**SOLICITATION AMENDMENT
RFP(LPTA) #2019019
CITY OF BUCKEYE
CONSTRUCTION & CONTRACTING DIVISION**

AMENDMENT #2

SOLICITATION: RFP# 2019019: FIRE STATION #705 TARTESSO

FS705 – ADD2 – SHEET A1.2

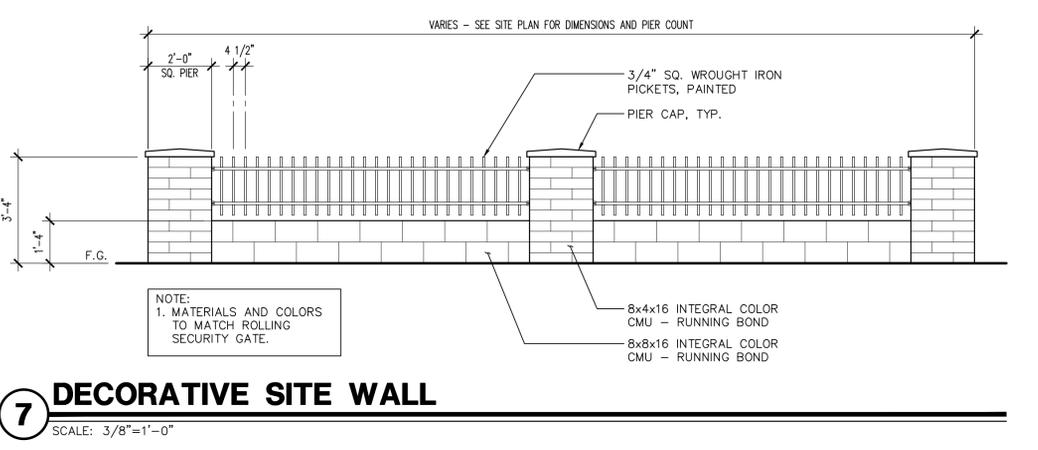
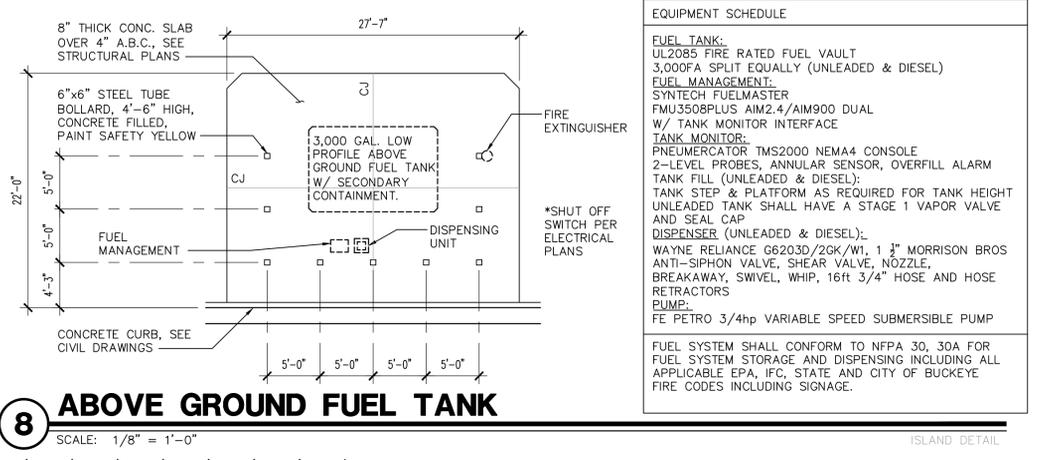
- Q19:** Please clarify if the City of Buckeye will be procuring the fuel dispensing system directly.
A19: No – contractor is responsible for this item. Refer to Attachment 2 updated Sheet A1.2 detail with current City of Buckeye OSM requirements listed on schedule.

- Revised equipment callouts and added schedule to drawing with City of Buckeye Fuel Dispensing Standards.

FS705 – ADD2 – ROHN 100FT MONOPOLE

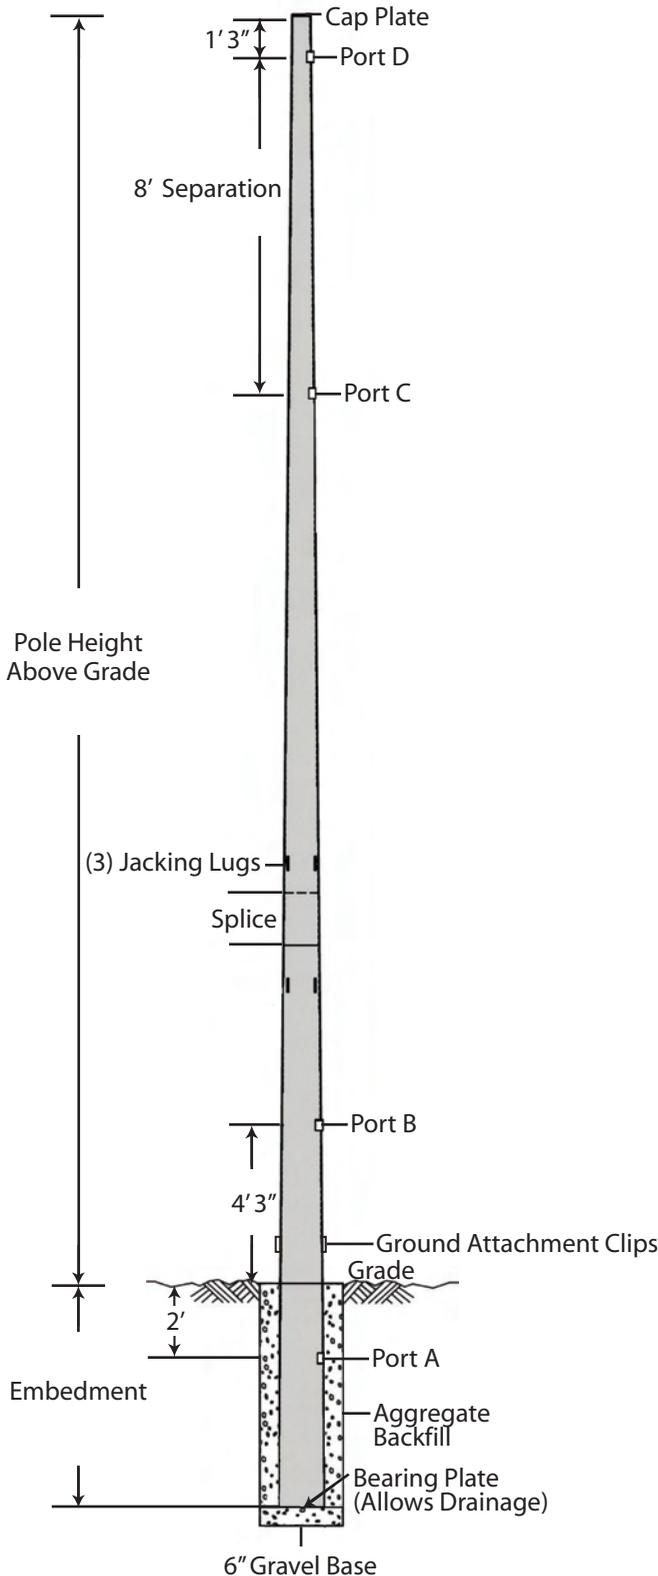
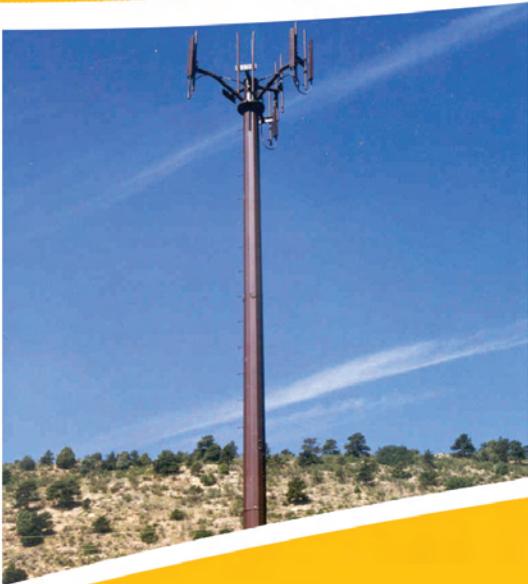
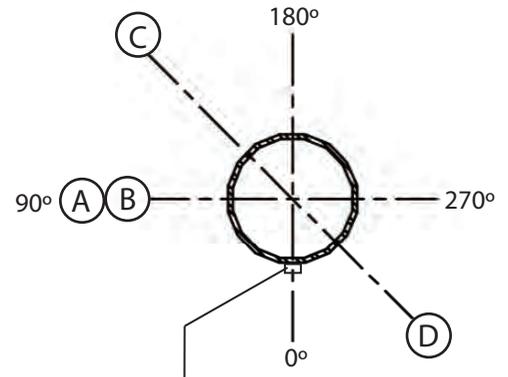
- Rohn 100ft Monopole Cut Sheet and ITS No 9 Vault Standard Detail.

FS705 – ADD2 – SHEET E1.1

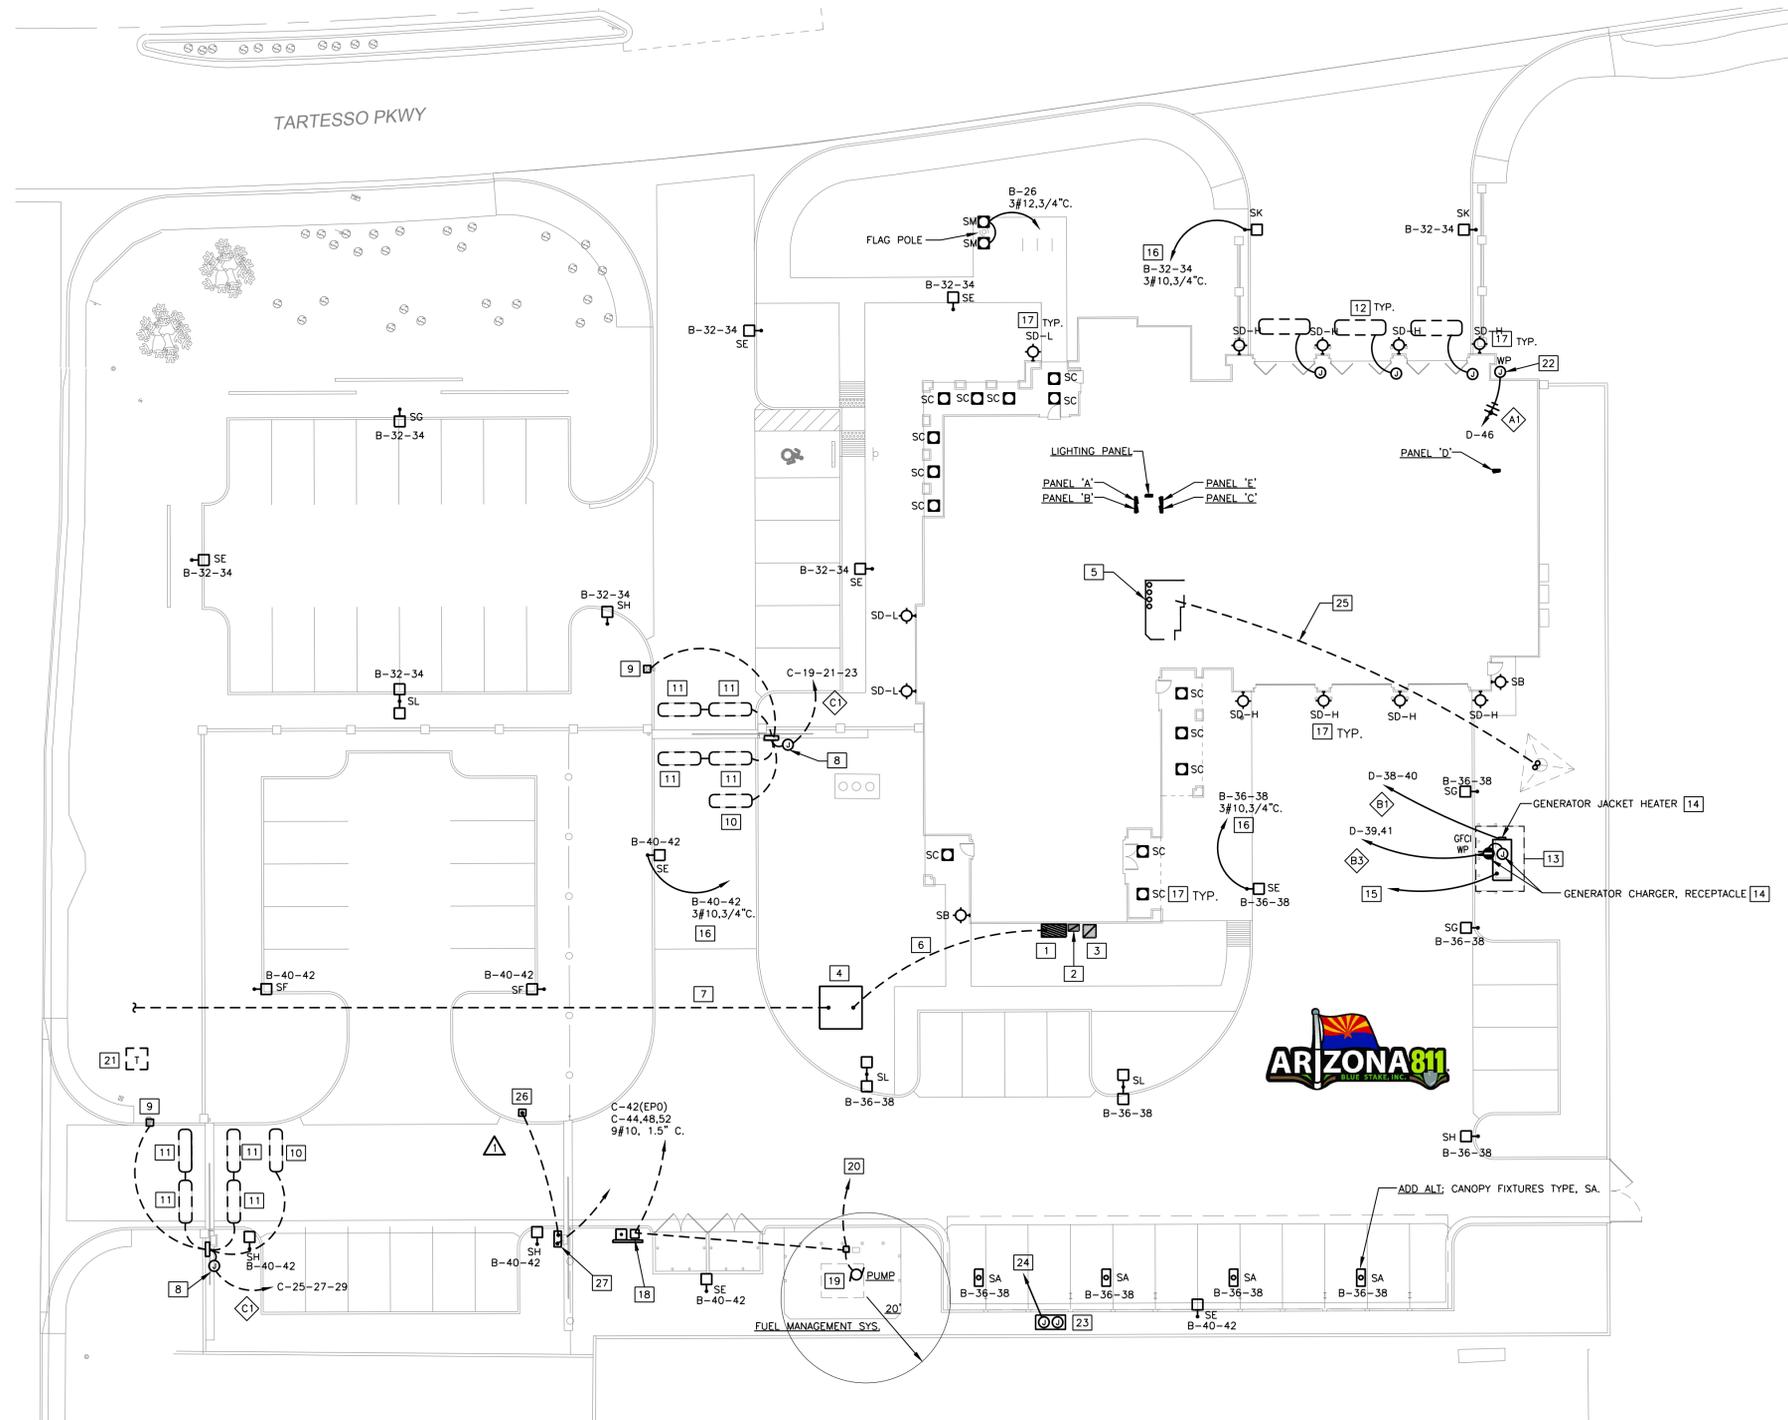
- Clarification of electrical plans to reflect Access Control matching Architectural plans.

- Clarification of electrical plans to reflect City IT requested conduit and data / TV locations.
